Addendum 4

Date: 10/28/22

Addendum 4 Items:

S3.1

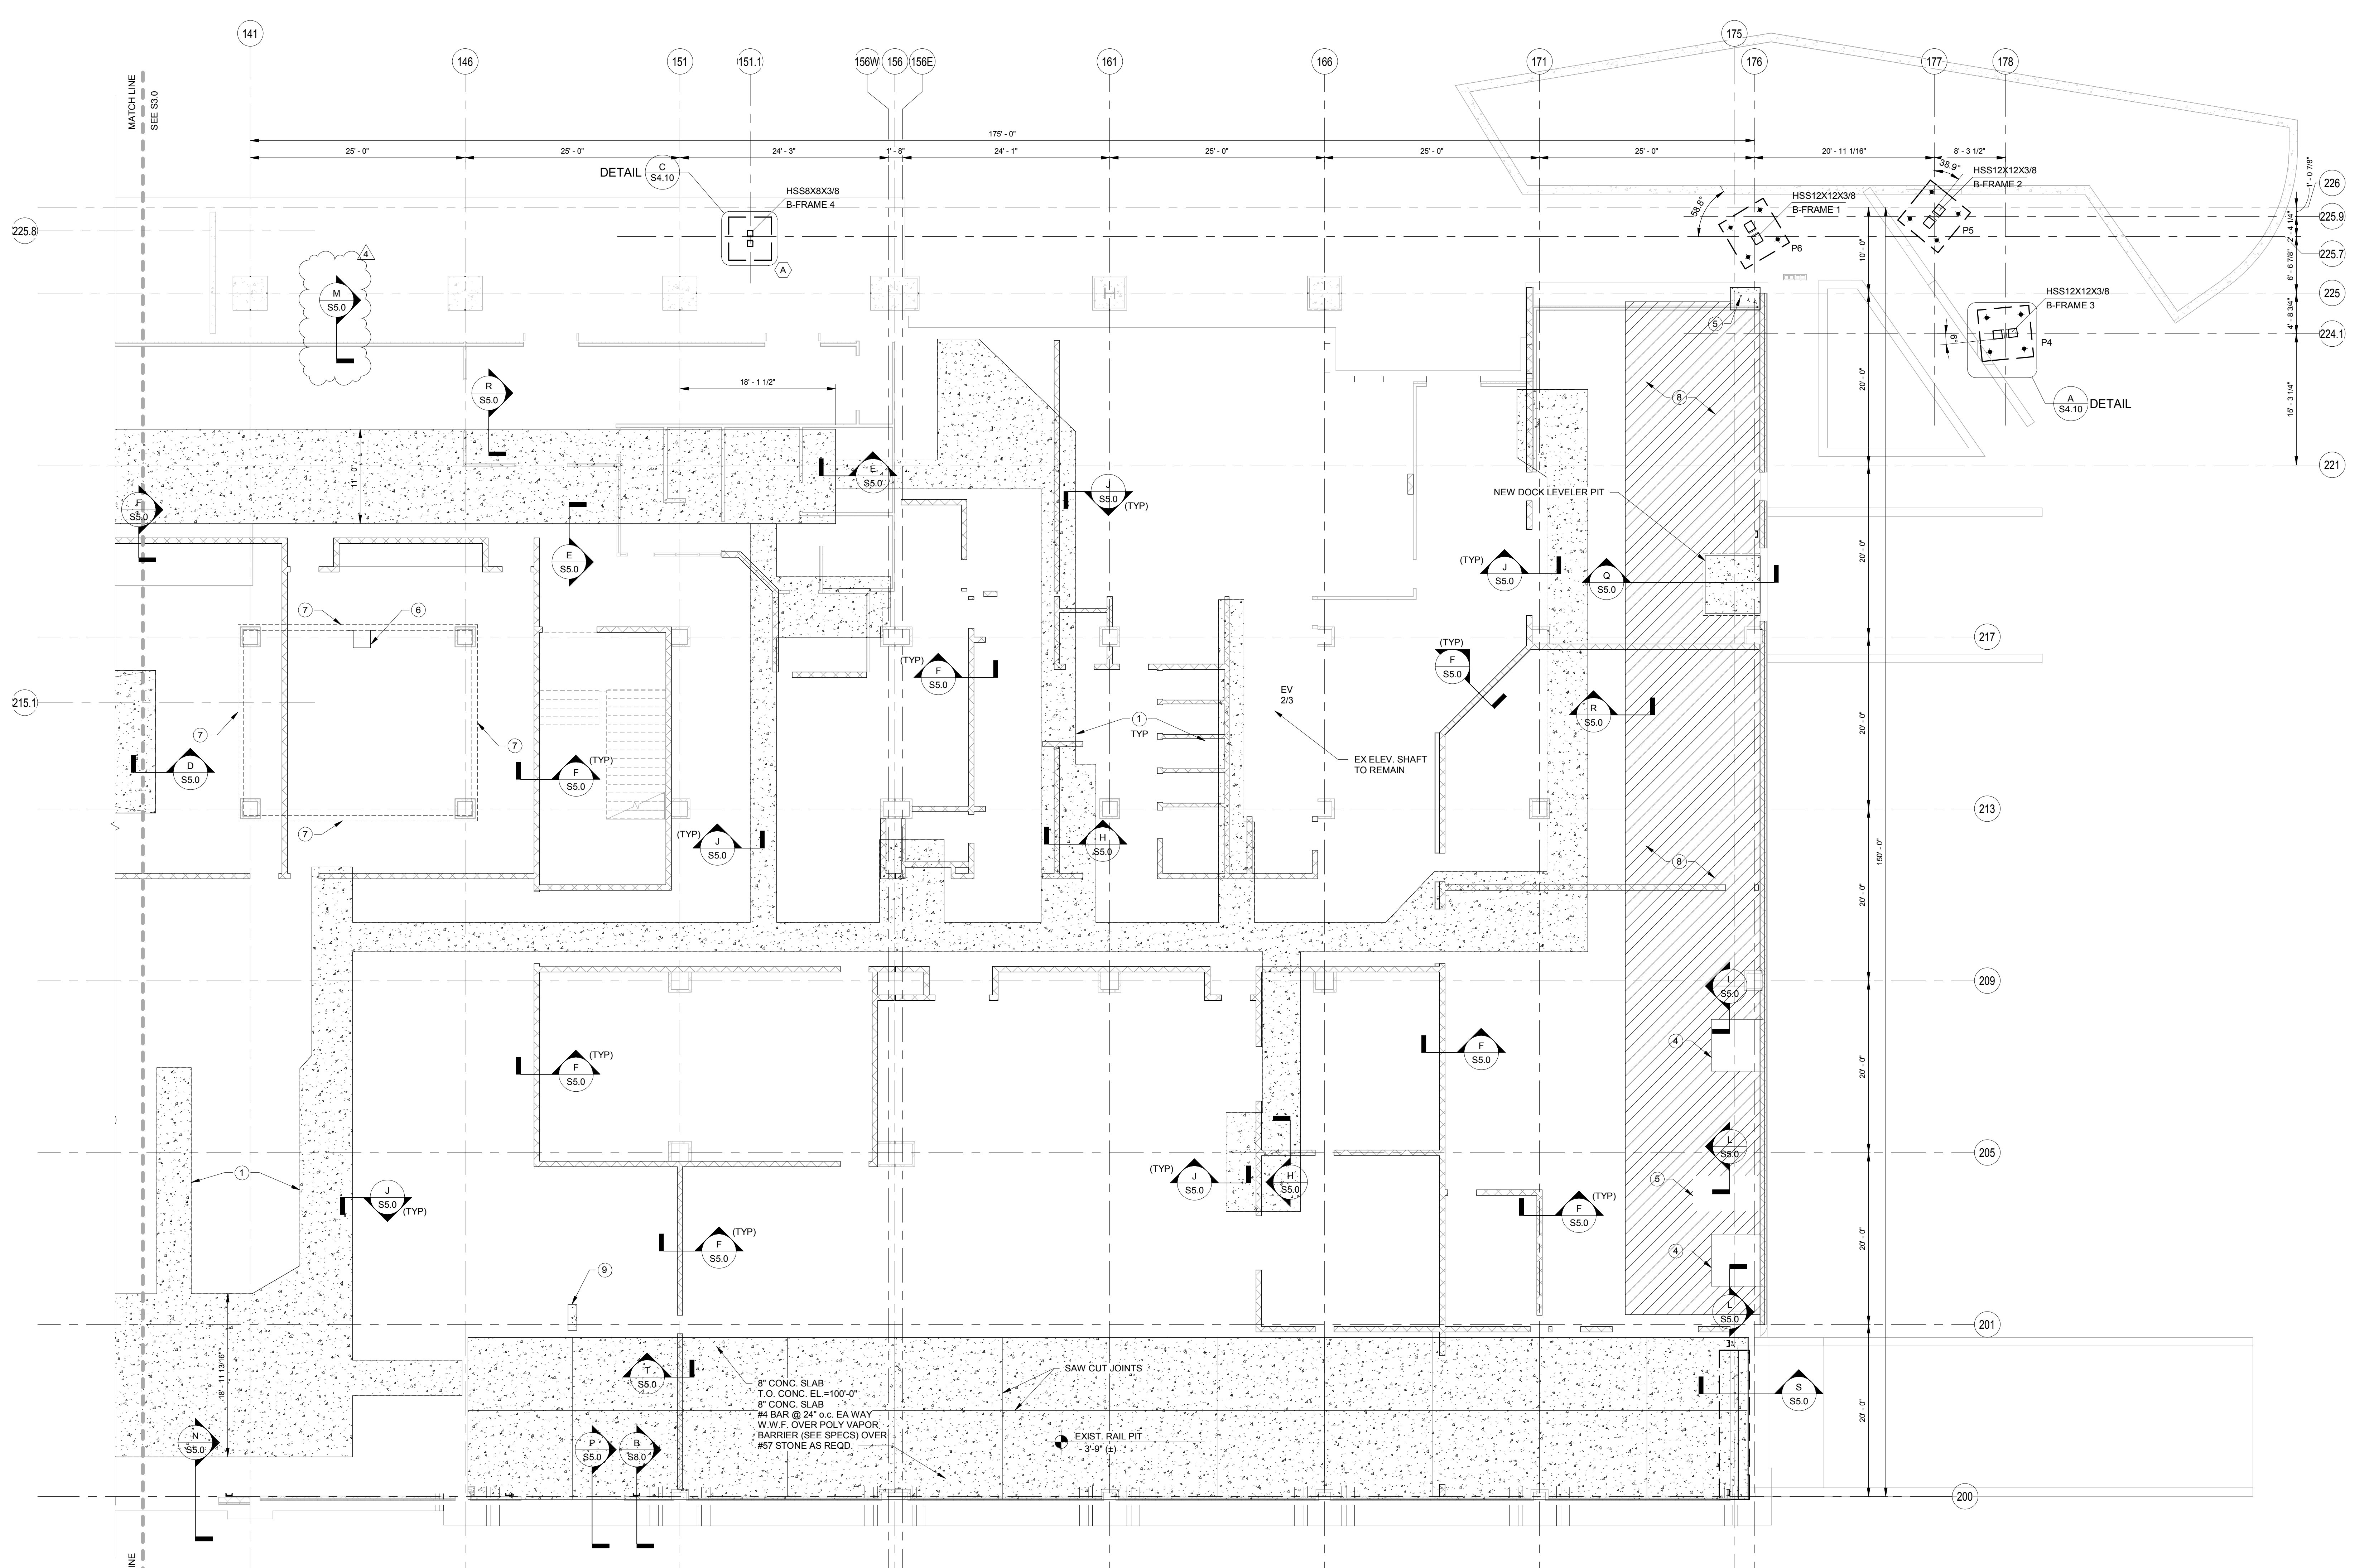
Refer to sheet S3.1
See clouded added section M/S5.0

S4.1

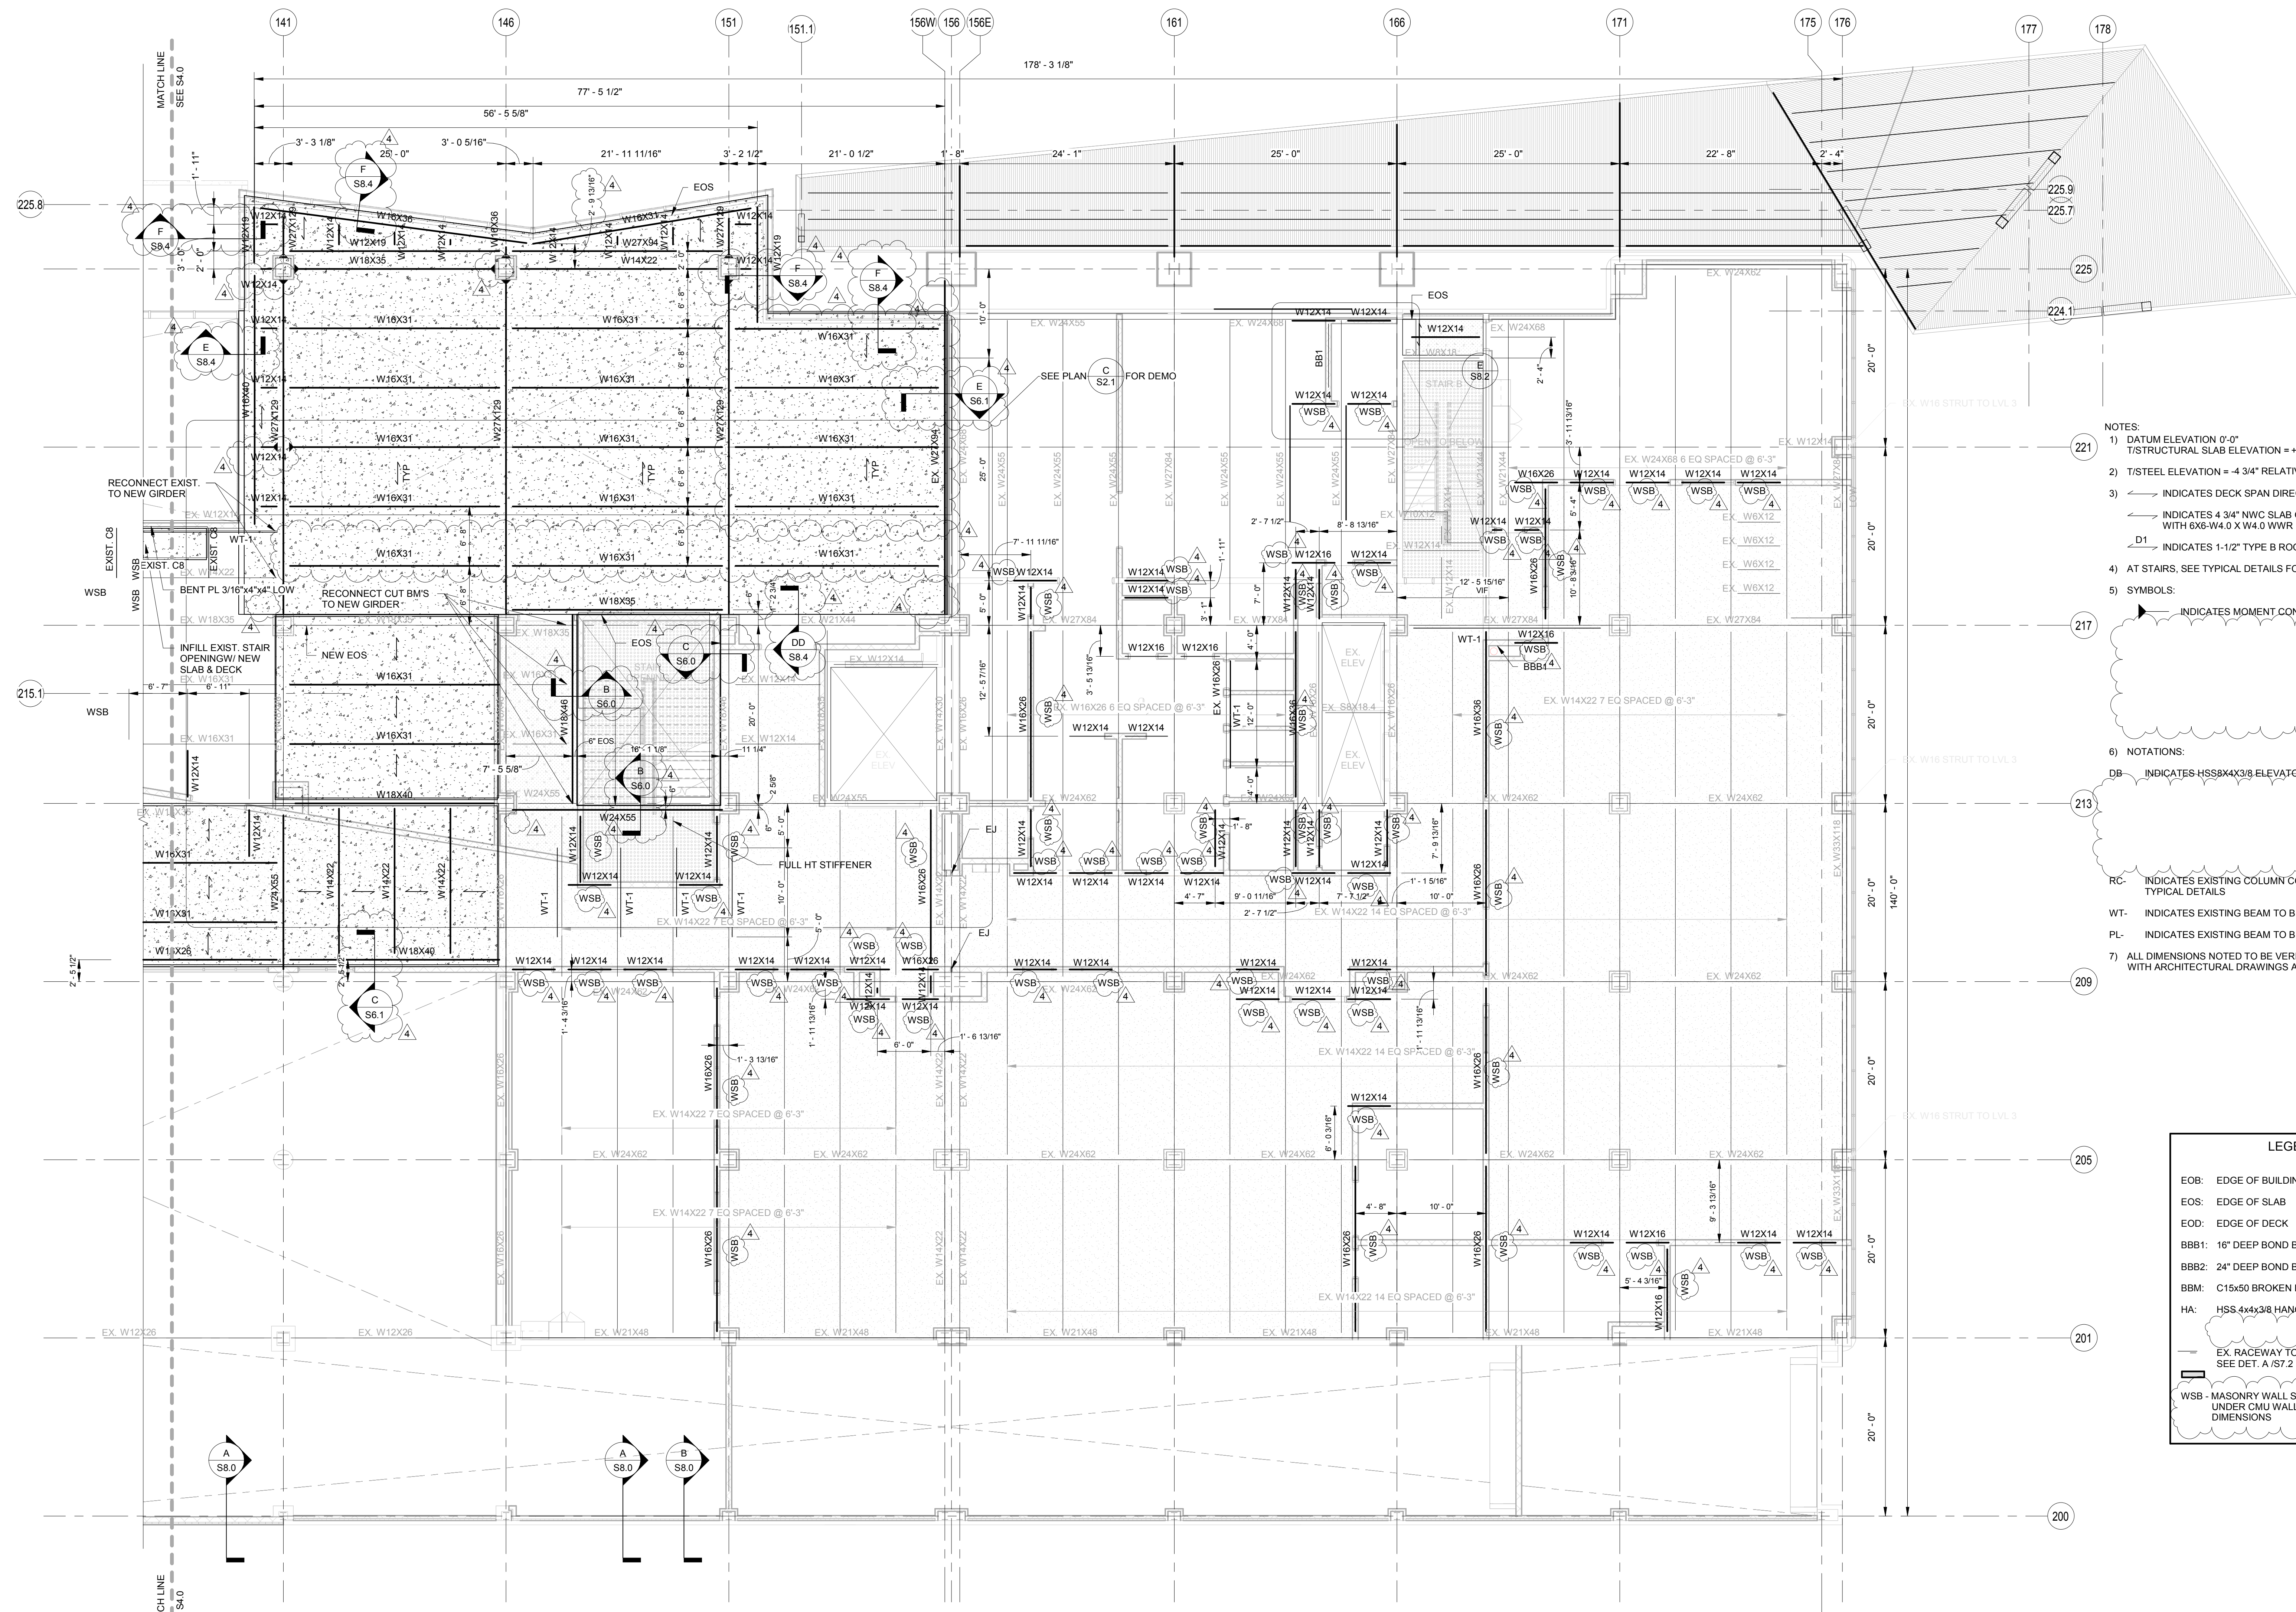
Refer to sheet S4.1
See clouded areas for added notes, revisions and sections

S4.2

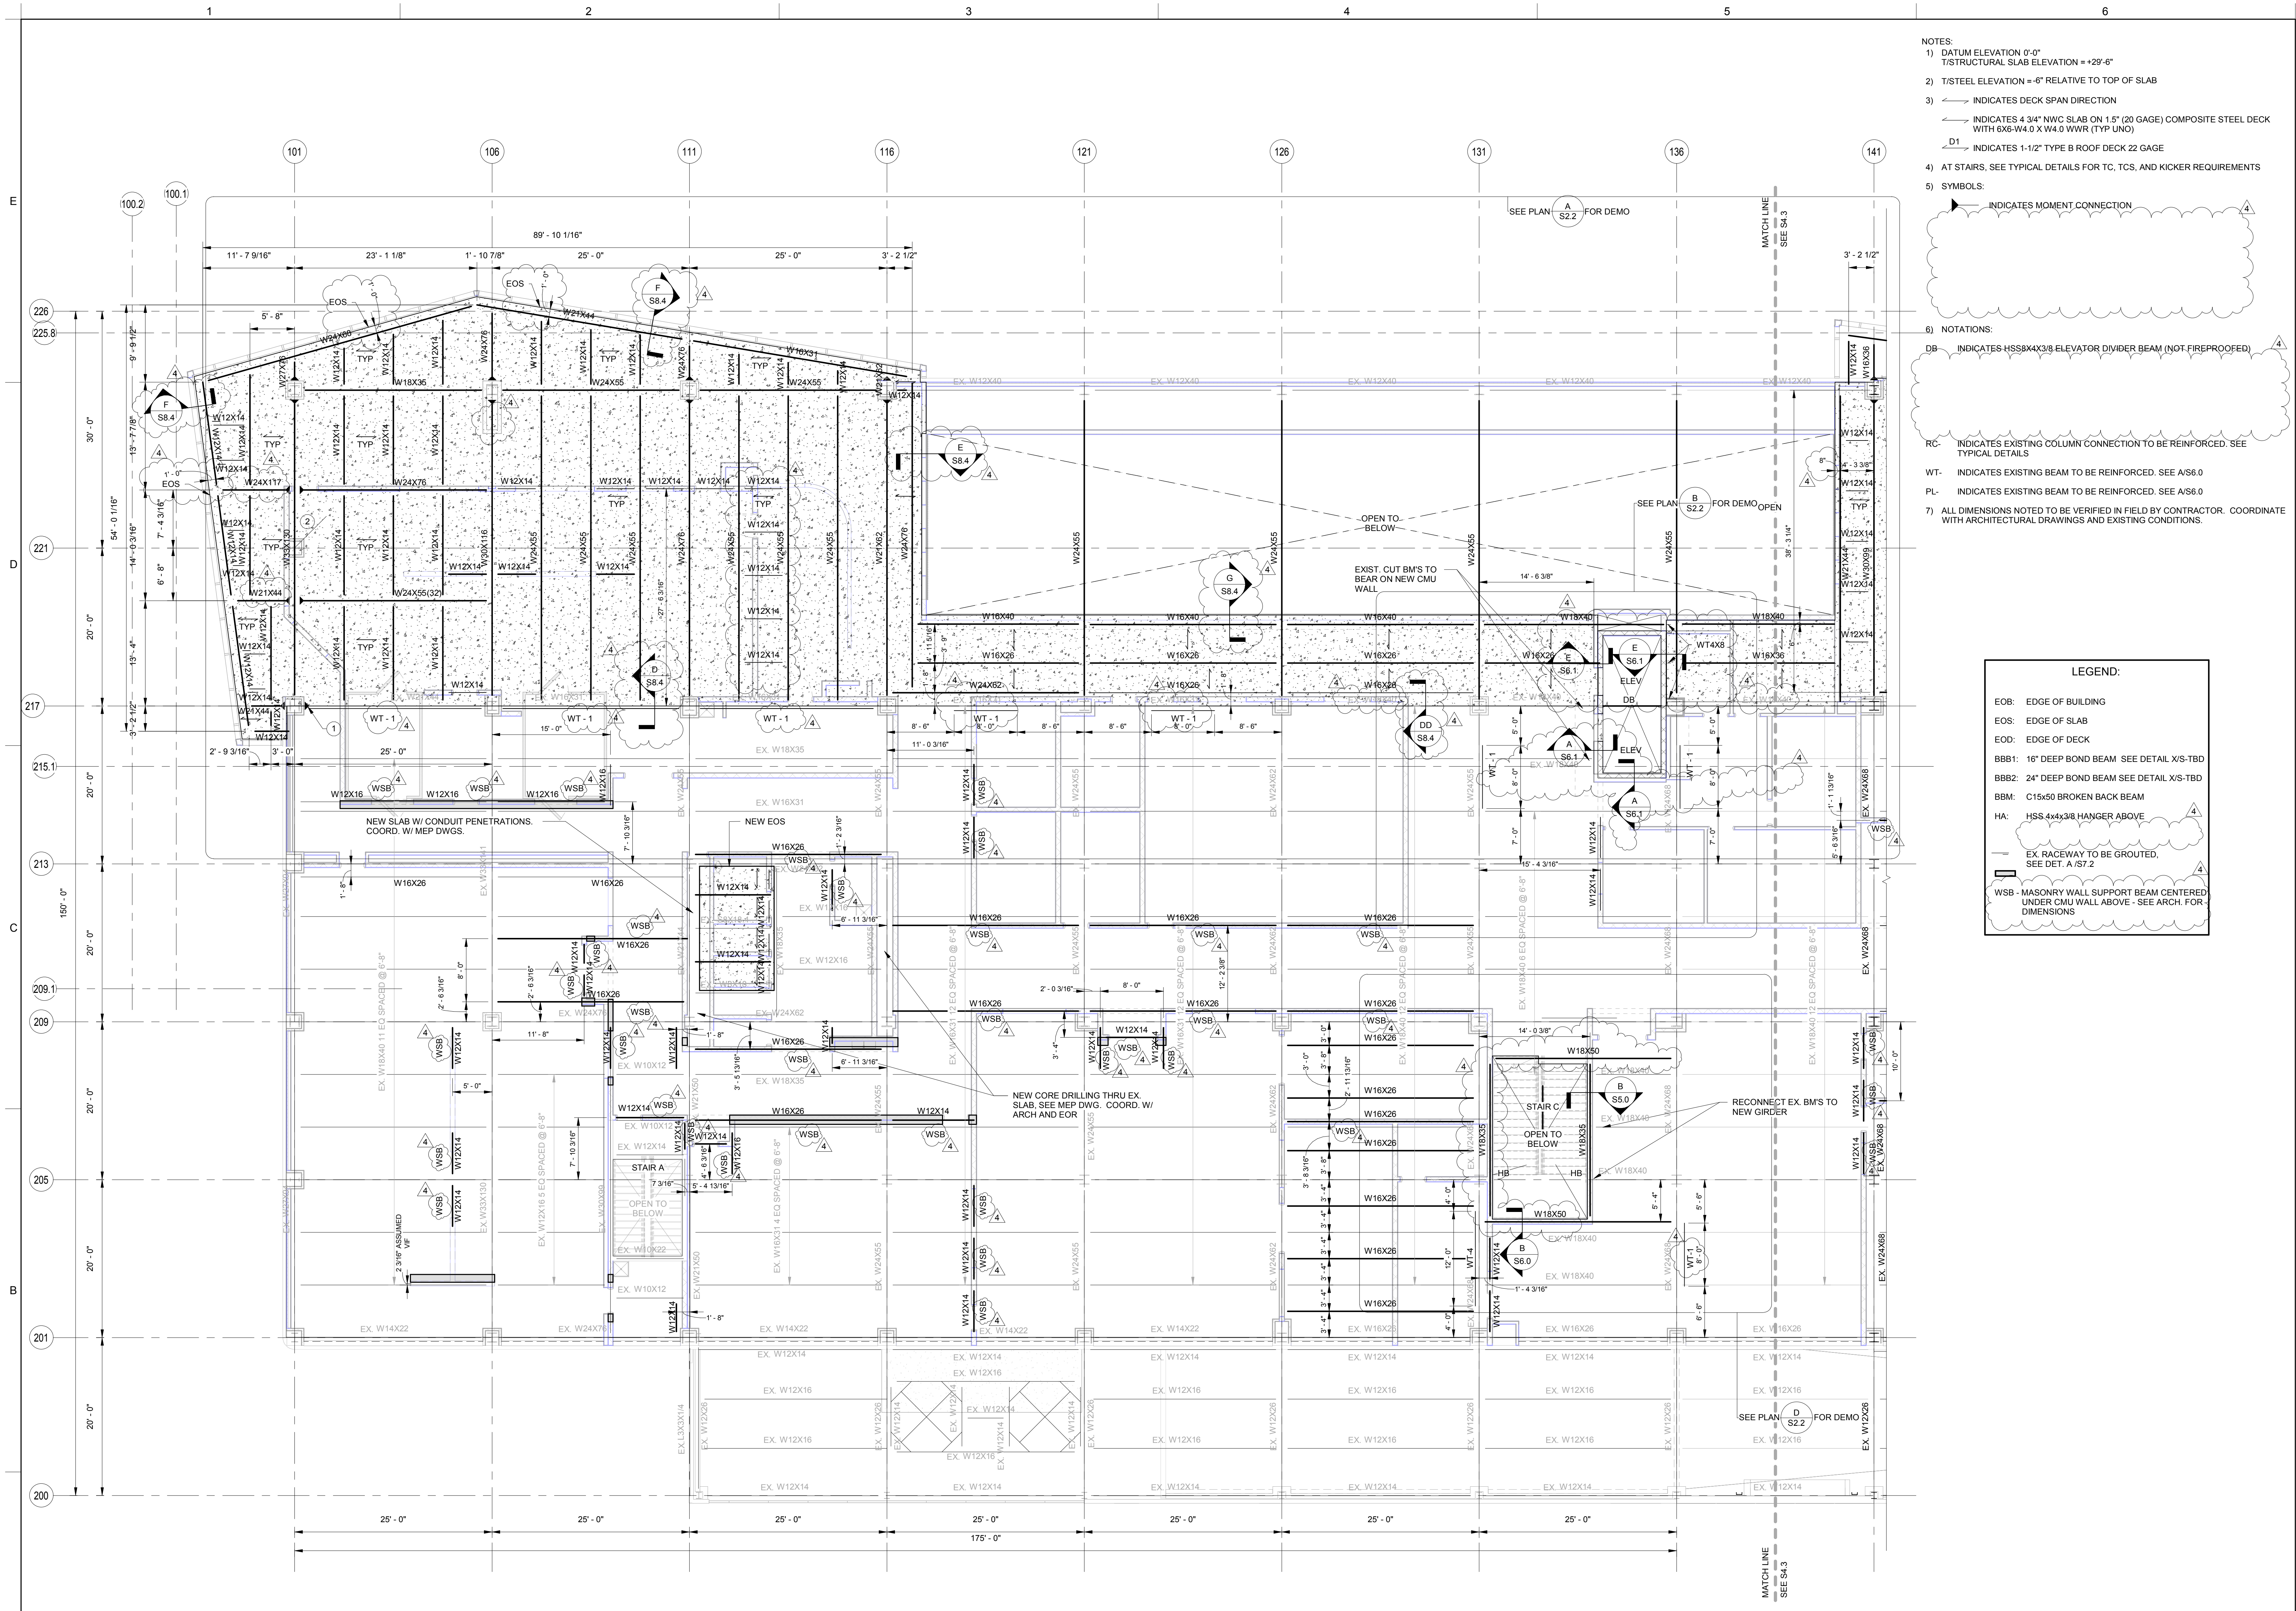
Refer to sheet S4.2
See clouded areas for added notes, revisions and sections
